NOTE: NEW MOUNTING DIMENSIONS FOR MTU2500/3000 GEN5 WALKRAMP GATE WITH 10" FLOOR!

L-401A-IM-MTU3WR GEN5
(MTU-GLR-WR-3000-A-G GEN5 SHEET2)

MTU3-WR TRUCK TRIM (10" FLOOR)
(MTU-GLR-WR-3000-A-G GEN5 SHEET3)

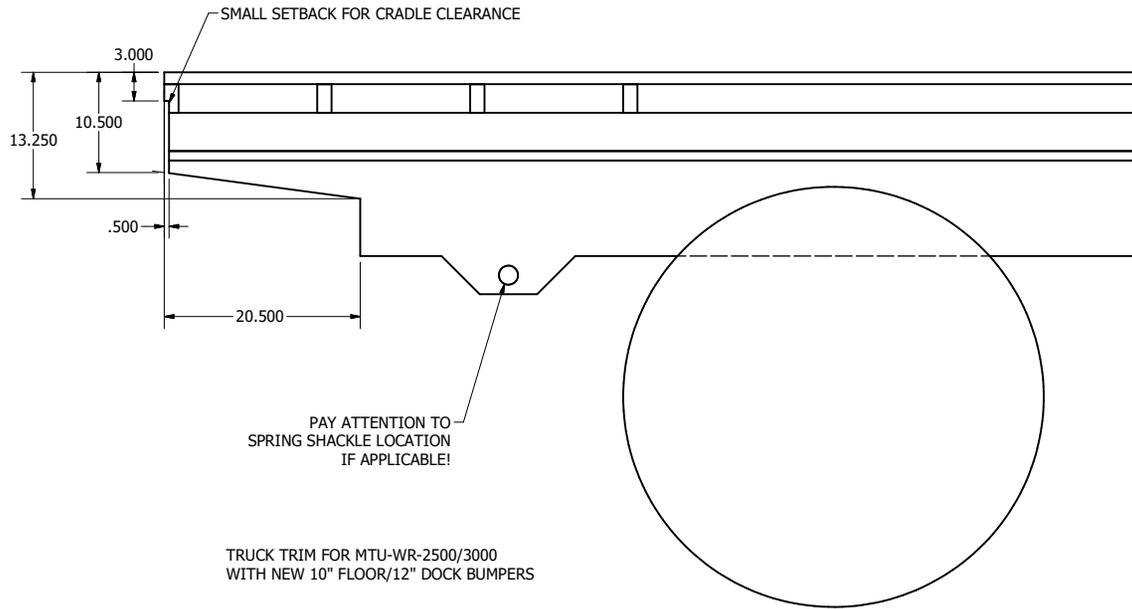
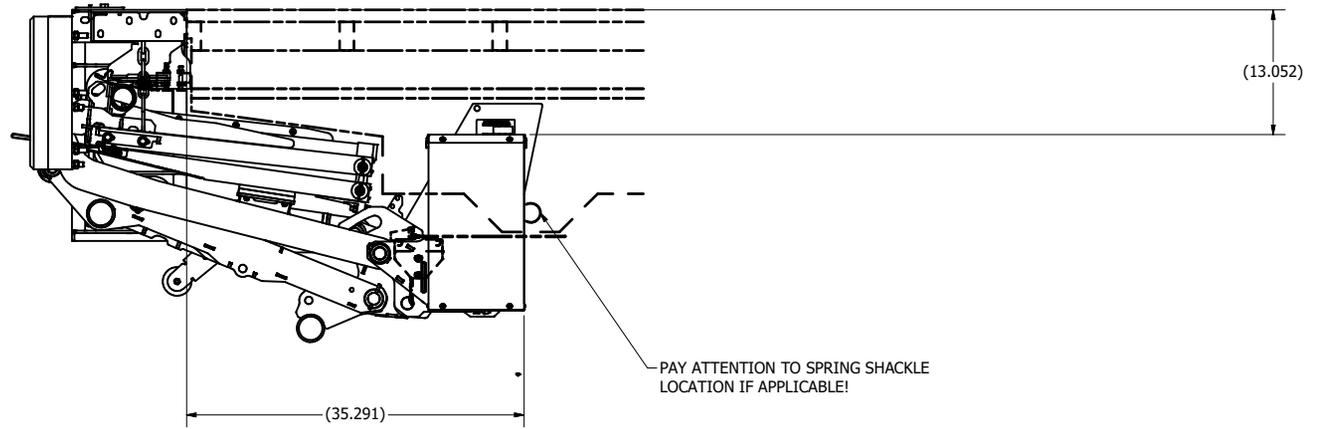
WITH THE SHALLOWER FLOOR EXTENSION, THE DIMENSION FROM THE FLOOR TO THE FRONT OF THE ADAPTER FRAME TUBE IS DIFFERENT FROM A NON-WALKRAMP MTU3. THE VERTICAL DIMENSION IS THE SAME. ARM LENGTH, BED RANGE, AND GROUND CLEARANCE ARE ALSO THE SAME.
